Process Sheet

Customer	: CU-DAR001 Dart Helicopters Services	Drawing Name	: FWD TUBE ASSEMBLY
Job Number	: 26568		
Estimate Number	: 10467		
P.O. Number	: <i>NIA</i>	Part Number	: D3391021
This Issue	: 4/5/2006 S.O. No. : <i>NIA</i>	Drawing Number	: D3391 REV D
Prsht Rev.	: NC	Project Number	: N/A
First Issue	: <i>NIA</i> Type : MACHINED PARTS	Drawing Revision	: D
Previous Run	: 26567	Material	: <i>NIA</i>
Written By	: <i>SEE COMMENT BELOW</i>	Due Date	: 4/28/2006 Qty: 1 Um: Each
Checked & Approved By	: <i>06/04/06</i>		
Comment	: Est. A 05.09.13 New issue KJ/JLM Est. B 06.02.10 Dwg rev.D ech 773 EC

From: David Shepherd [davids@dartaero.com]
Sent: Friday, April 21, 2006 10:59 AM
To: Peter Hum
Subject: Re: D3391-1 fwd tube tolerance update

SECTION D-D

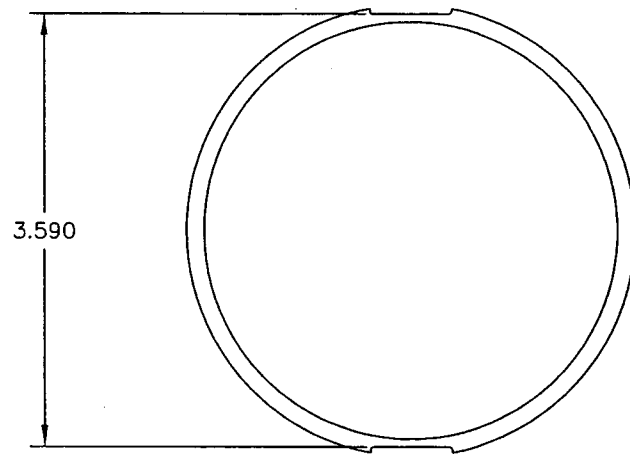
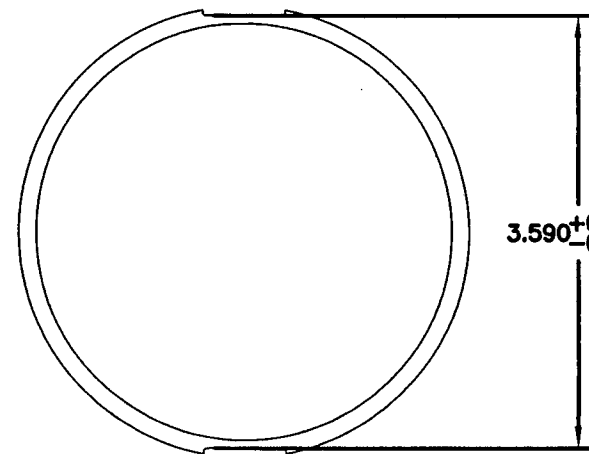
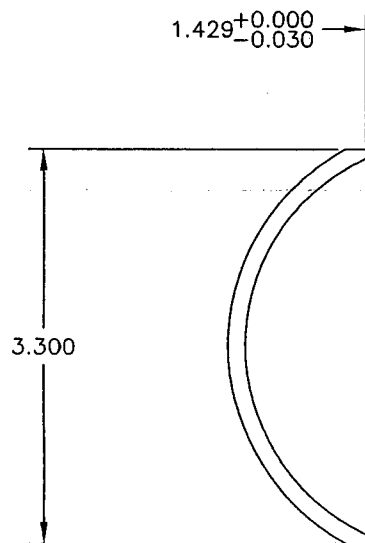
> David,
>
> I've attached a sketch (the proposed changes are in black),
>
> In machining the D3391-1 fwd tube, the dimensions of Section D-D and
Section
> C-C vary above/below the specified tolerance. In the majority of the cases
> the end result is more material and therefore an increase in strength.
>
> At the worst case tolerance (i.e. smallest area) the reduction in area is
> 0.5%. However in the critical section of the FWD tube, the ultimate margin
> of safety is 21%. Therefore, this reduction in area is very small compared
> to the overall margin of safety; therefore it will be acceptable.
>
> Can these deviations be applied to current and future production (will
> require drawing update)?
>
> Peter
>
>

1) WORST CASE IS MORE MATERIAL

The deviation on tolerance shown in your sketch is acceptable for current production and would be acceptable for future production with a drawing change and confirmation that production can work to these tolerances.

When you do the design review for the drawing change, ensure to include the sketch. I would suggest that we submit the updated dwg when we submit the drawings for the cable guard.

SECTION C-C

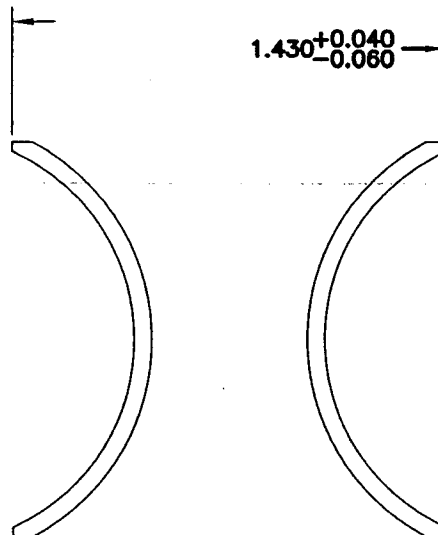
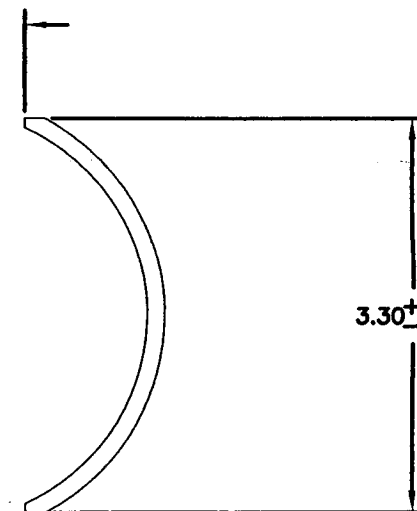
- 1) AT THE WORST CASE THE AREA IS REDUCED BY 0.5%
- 2) THE ULTIMATE MARGIN OF SAFETY OF THE CRITICAL SECTION IN THIS REGION OF THE SKIDTUBE IS 21%
- 3) THEREFORE, THIS REDUCTION WILL NOT BE A FACTOR
